Landscaping

1. Originally submitted were Outline Landscape Plan LC-2901-03 and Outline Landscape Plan LC-2901-04. I'm not clear why there are two plans that are so similar, but slightly different – I suggest it would be preferable to have just one to avoid confusion. 03 has shrub mix and hard surfacing details, but also shows trees (but no palette provided), whereas 04 has the shrub and tree palette with no hard surfacing details. 03 plan has 32 new trees; 04 plan has 30 new trees, so clarification is required as to which is proposed. In any case, the proposed trees are not acceptable as the proposals do not meet with Tree Strategy requirements. I note that revised plans – Rev A of both have now been submitted to address Ecology comments.

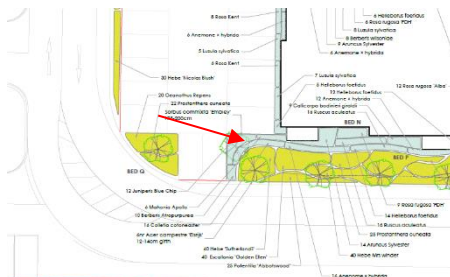
2. With reference to **Landscape Plan LC-2901-03 A and Outline Landscape Plan LC-2901-04 A:**
3. There is still a discrepancy in tree number between the 2 plans (if there are to be two plans) that needs to be resolved. The tree planting palette on the 04 plan indicates 32 trees, not 30, and lists the same species as the original plan, hence tree species has not changed to improve biodiversity value. The following are contrary to our Tree Strategy hence should be reconsidered and other points resolved: **Adjusted there are 32 trees**

4. *Prunus* (currently 9 trees) – **Changed to Hawthorn and *Malus sylvestris***.
5. *Acer ginnala* – non-native, no discernible wildlife value; ornamental only. **Sub for *Malus sylvestris* and *Pyrus cordata***

6. *Betula nigra* - non-native, no discernible wildlife value; ornamental only **sub for *Betula pendula***
7. Missing tree label – I would expect this to be a large canopy tree: **Hornbeam label added**

8. Diversity – we expect the trees proposed to consist of no more than 30% of any one family, no more than 20% of any one genus and no more than 10% of any one species. The current mix doesn't meet this requirement, e.g. 59% is from the Rosaceae family, 28% is from the *Acer* genus and 28% from the *Prunus* genus. When the proposed trees are amended, diversity mix should be reconsidered and the mix stated. **Adjusted to meet requirements – no genus above 19%**

9. No tree pit details have been provided. This should include pits for soft landscape and hard landscape, root barrier provision where appropriate (positions shown on the landscape plans) and confirmation of soil volume for beds B, F & Q and for the trees in the hard surfacing adjacent to beds B & F. Tree pit details added – **added - all the trees are adjacent to soft areas and should have sufficient rooting area to avoid expensive soil cells**

10. **No basic establishment details have been provided – notes on planting plans are normal for this.**
11. I note the shrub planting mixes have been revised and as this is in response to ecology comments, I'll leave GS Ecology to confirm acceptable of those. **Done**
